To: T10 Membership
 Subject: DRIVER/RECEIVER ANALYSIS
 Date: May 1, 1997

Shown below is an analysis of both the driver and receiver response using the biased asymmetrical design. This expands on the analysis that Kevin did on the driver and includes the effects of the receiver on the response of the system under worst case conditions using the limits of the specification values in SPI 2. This shows the system would be much better behaved without the bias and the potential errors can add to very significant distortion of high speed pulses. Also from the equations one can see that the receiver response to assertion and negation drive level mismatch in the absence of a bias. At the very least there may be a need to tighten values in the current specification to allow error free operation at SPI 2 rates.

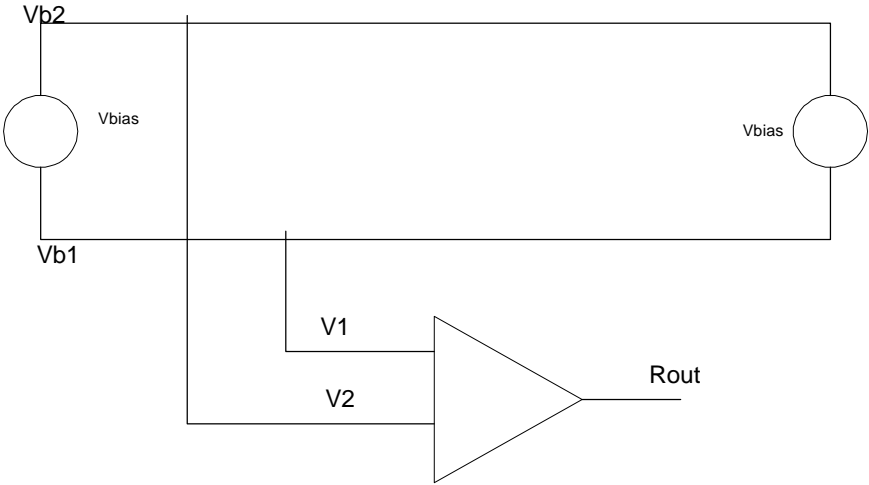
- Case 1:
 $V_a = 441 \text{ mv}$
 $V_n = 443 \text{ mv}$
- Case 2:
 $V_a = 518.5 \text{ mv}$
 $V_n = 566.9 \text{ mv}$
- Case 3:
 $V_a = 543.5 \text{ mv}$
 $V_n = 541.9 \text{ mv}$
- Case 4:
 $V_a = 466 \text{ mv}$
 $V_n = 418 \text{ mv}$

Case 2/4 are the worst case and result in asymmetry of 9.3% and 11.3%. Even using the design point of 492.5 mv (a very substantial drive level) the minimum drive level produced is 418 mv which is a 15% reduction. This can come into significance if the design point had been chosen lower in the allowable range.

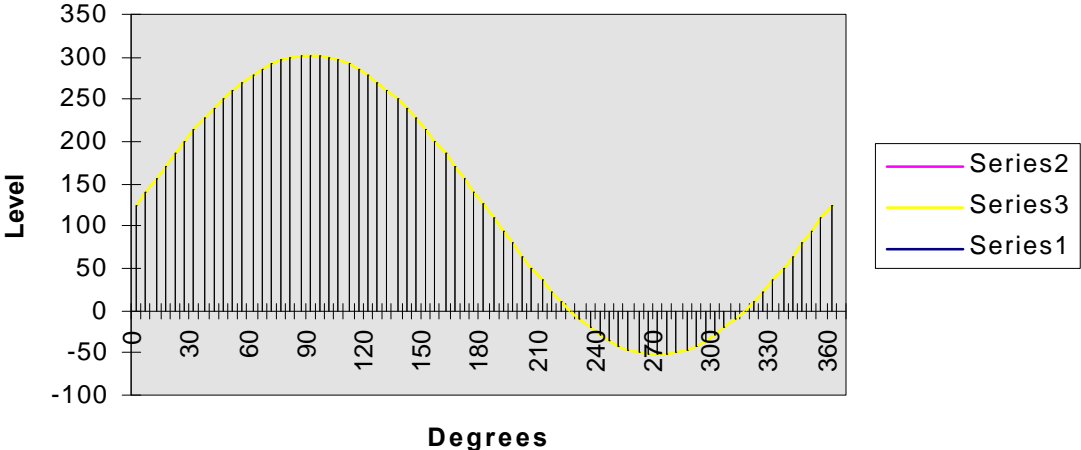
A plot of this function is shown below. From the values the signal distorts from a 50/50 duty cycle by 44% (a perfect 50/50 duty cycle becomes 28/72) allowing for a 30 mv receiver threshold. This most likely would not function and certainly would not function at 80 MHz. This also violates the 4:1 rule for the positive and negative transitions at the receiver.

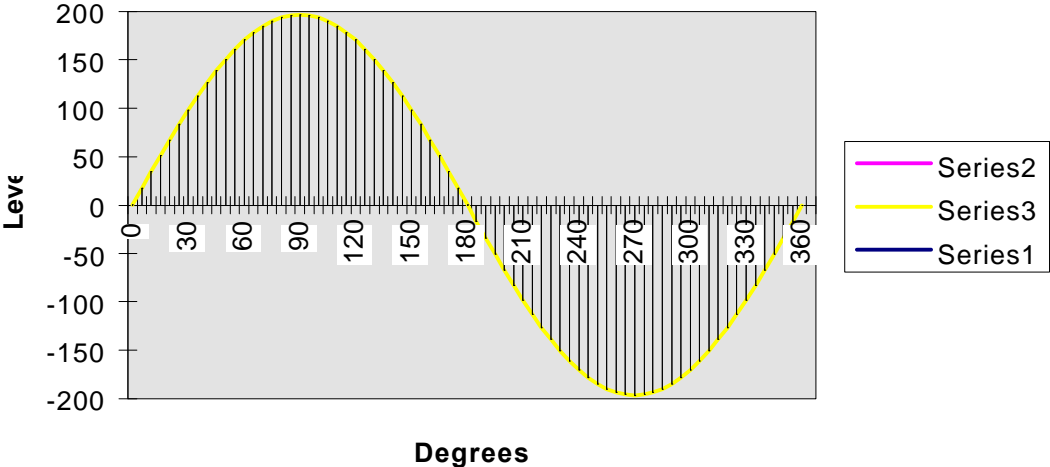
If the design drive level were reduced to 270 mv which is the limit of the specification today and the same impedance and terminator bias were used the result would be the curve shown below. This shows a distortion 55% and the 50/50 duty cycle would become 22.5/77.5.
